ATTACHMENT TO LICENSE AMENDMENTS

Revise Appendix A as follows:

SAFETY EVALUATION BY THE OFFICE OF NUCLEAR REACTOR REGULATION

OCONEE NUCLEAR STATION, UNIT NOS. 1, 2 AND 3

Figure 3.5.2-1C3

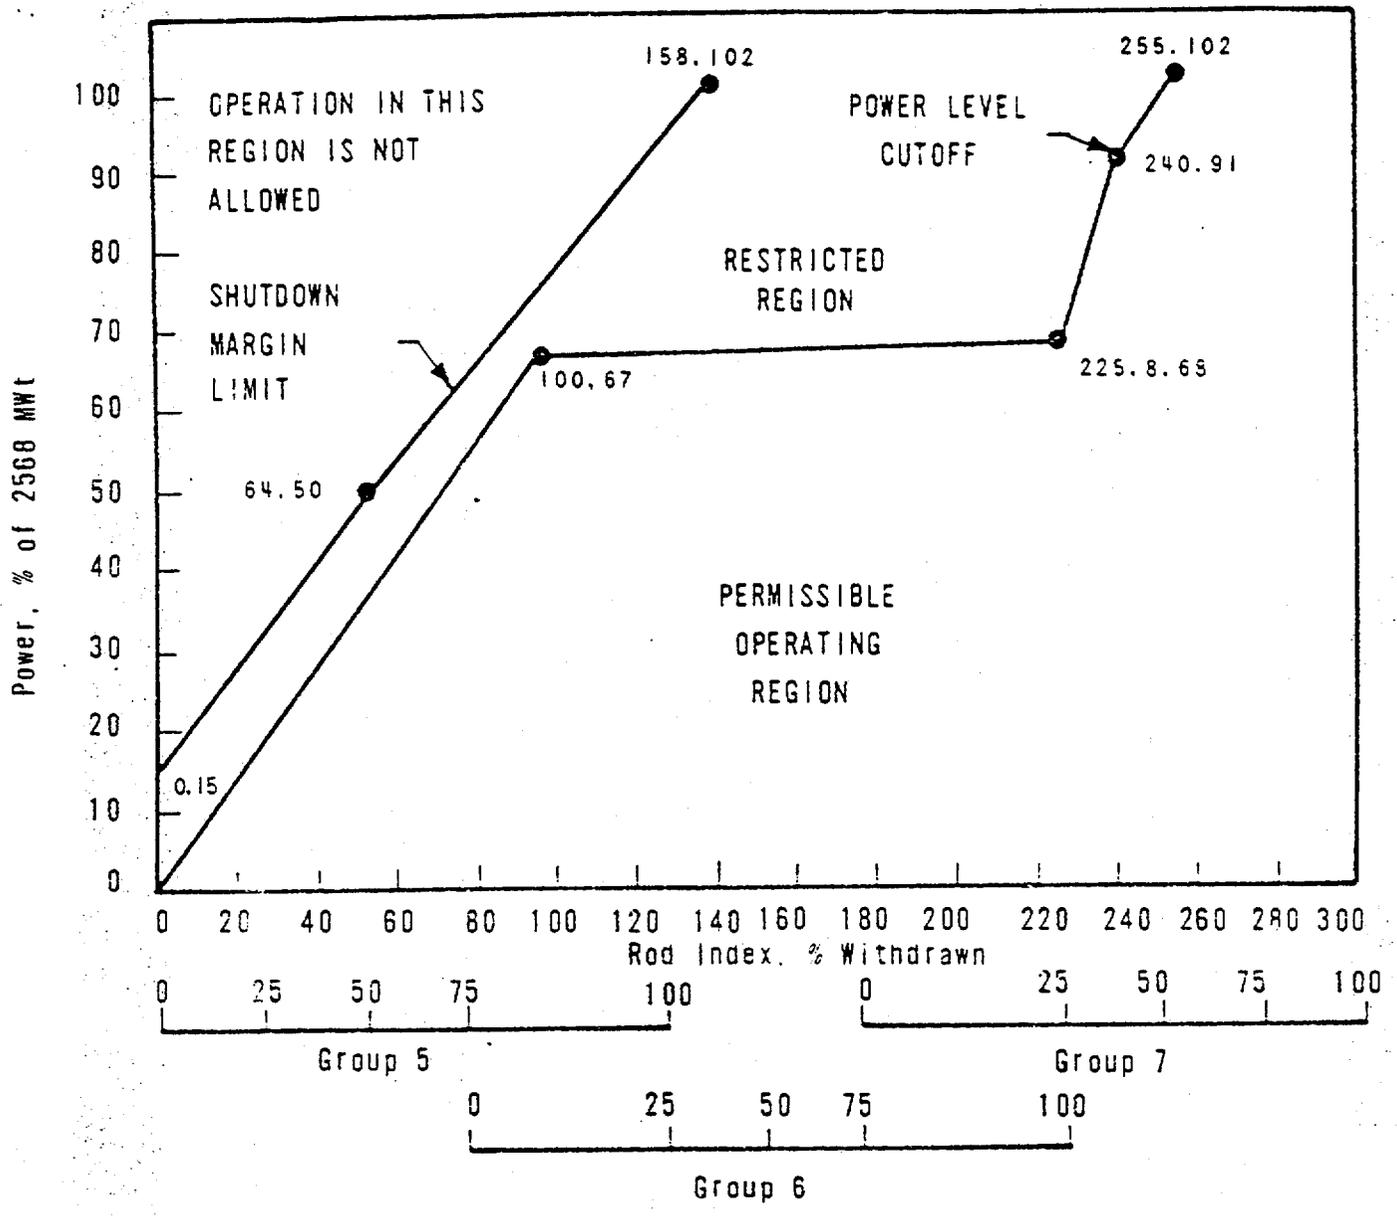
The licensee assessed the applicability of the existing Technical Specification limits for the extended Cycle 2 in a manner similar to that performed for the Cycle 2 reload. As a result of this assessment, it was determined that the operational control rod position limits (Technical Specification Figures 3.5.2-1C3 and 3.5.2-2C3) and the power imbalance limits (Technical

Specification Figure 3.5.2-3C3) would require slight modifications to account for limiting conditions which would exist in the extended part of the cycle.

ROD POSITION LIMITS FOR FOUR-PUMP OPERATION AFTER 225(+10) EFPD Unit 3
